**Planning Department
Transportation Development Services**

**Re: Davita Dialysis Center - Albuquerque, 5207 San Mateo Blvd.
Traffic Circulation Layout
(F17-D095A)**

Based upon the information provided in your submittal received 3-04-15, the above referenced plan cannot be approved for Building Permit until the following comments are addressed:

C1.3

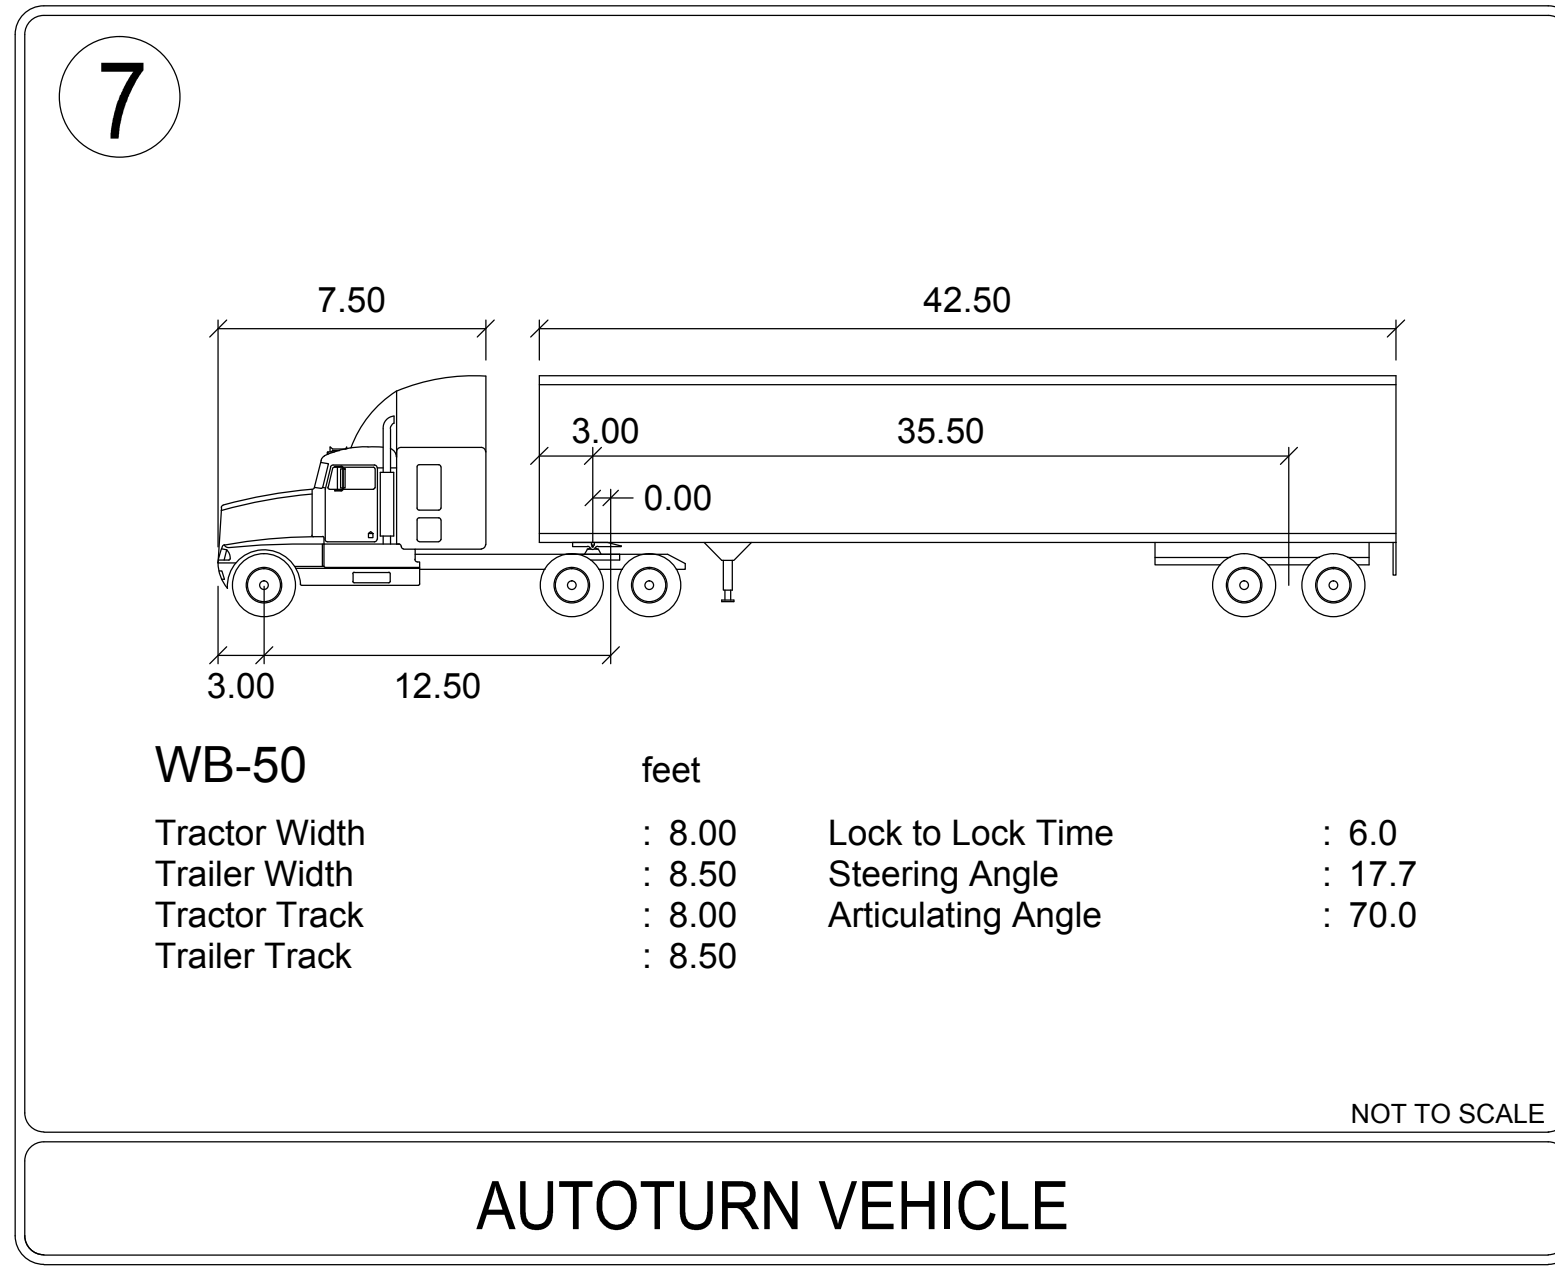
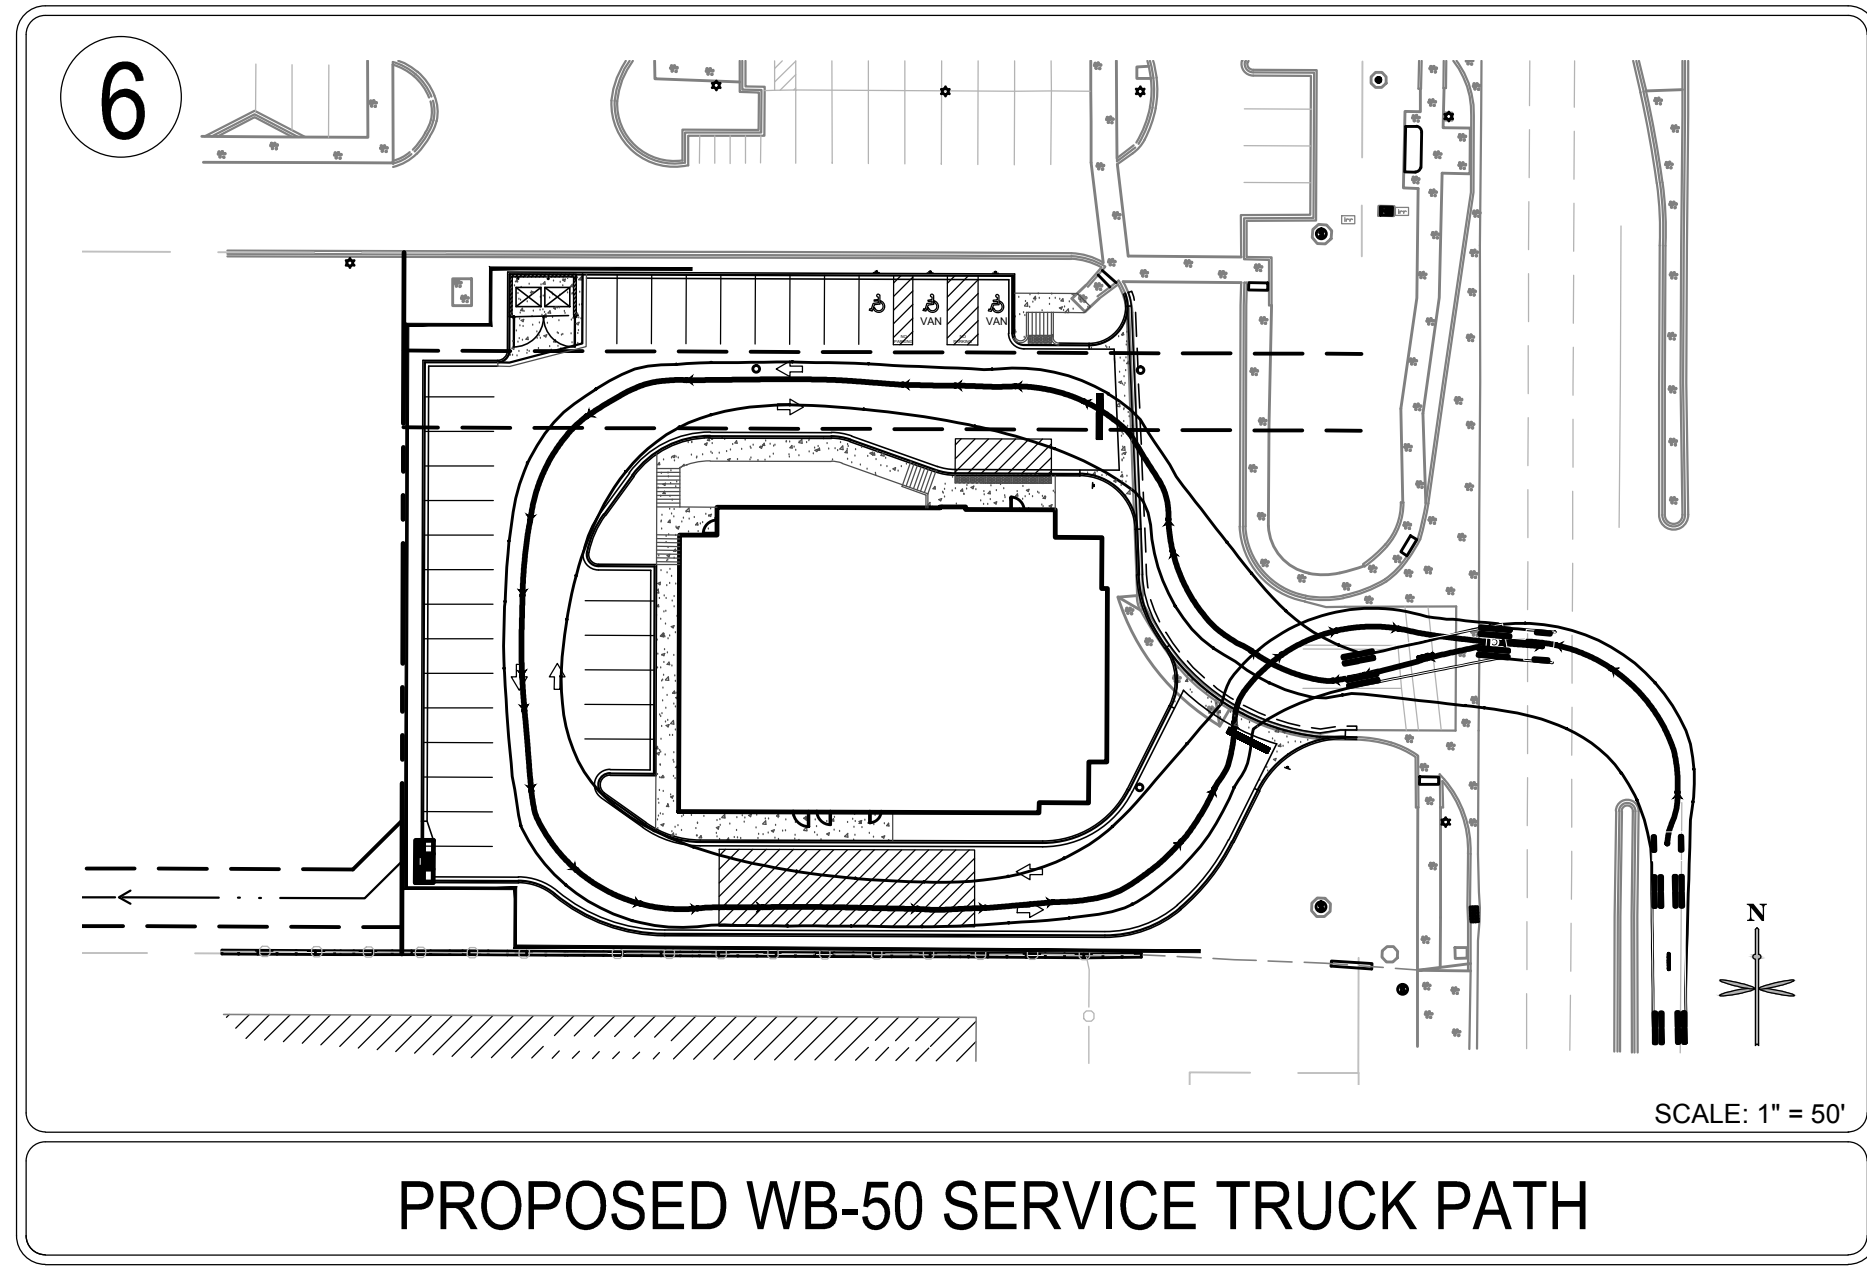
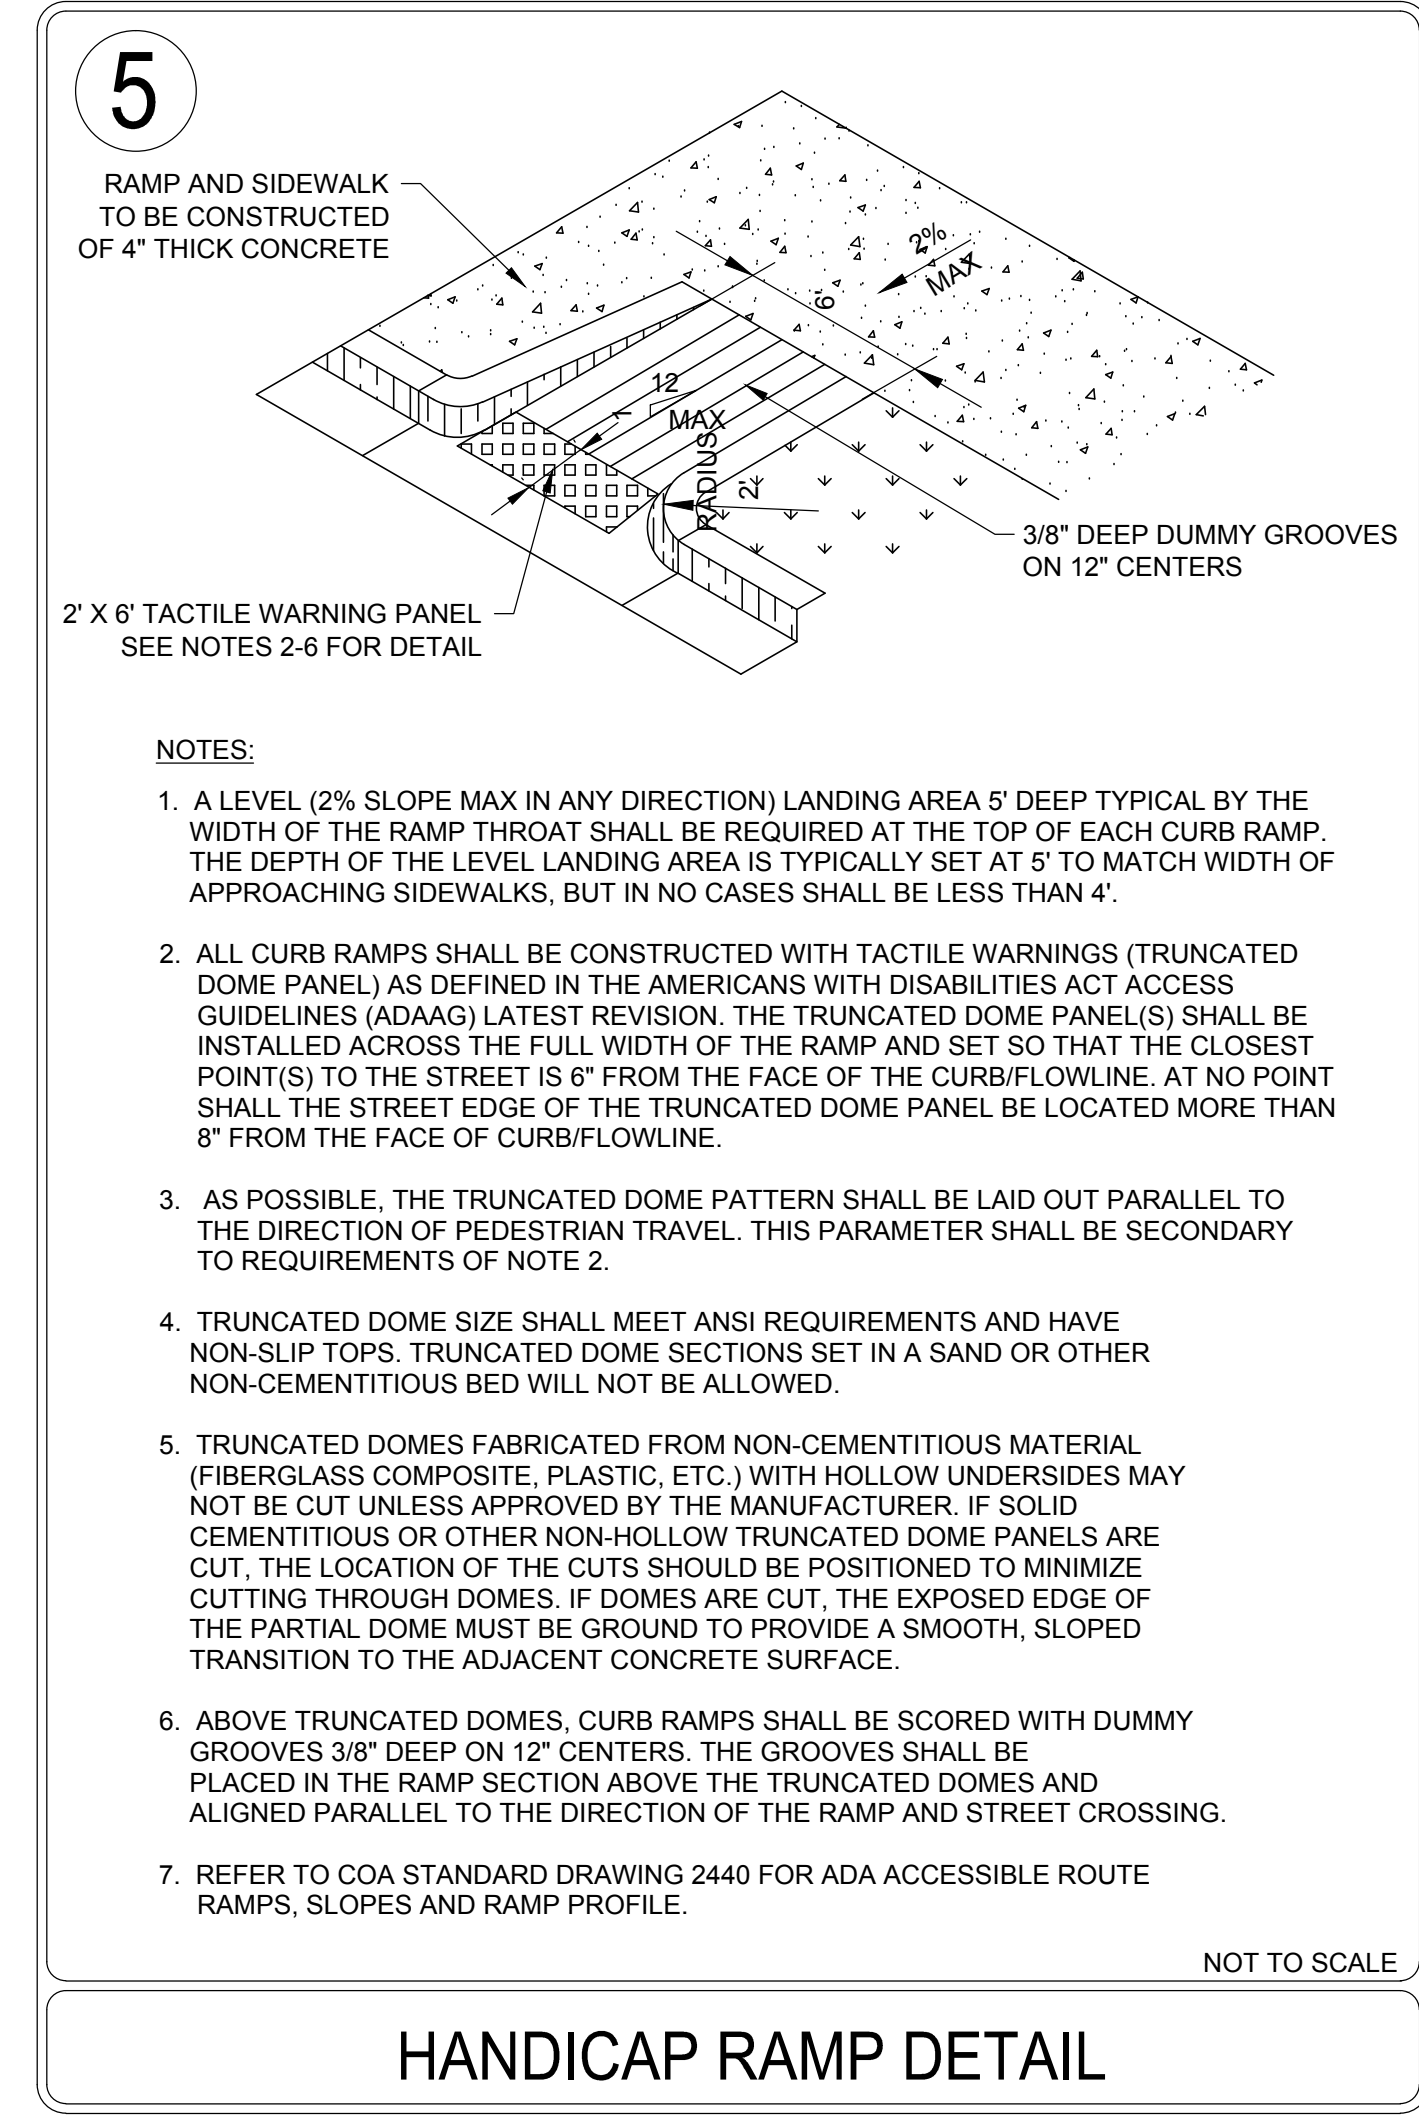
6. The ADA van accessible sign must have the required language per 66-7-352.4C NMSA 1978 **"Violators Are Subject to a Fine and/or Towing."**
7. Per the DPM, a 6 ft. wide ADA accessible pedestrian pathway is required from the public sidewalk to the building entrances and from the HC parking stall access aisles to the building entrances. Clearly show this 6-foot wide ADA pathway, and if the "Existing ADA Ramp to Remain" needs to be upsized to provide a 6-foot ADA accessible route, remove and replace this ramp to meet
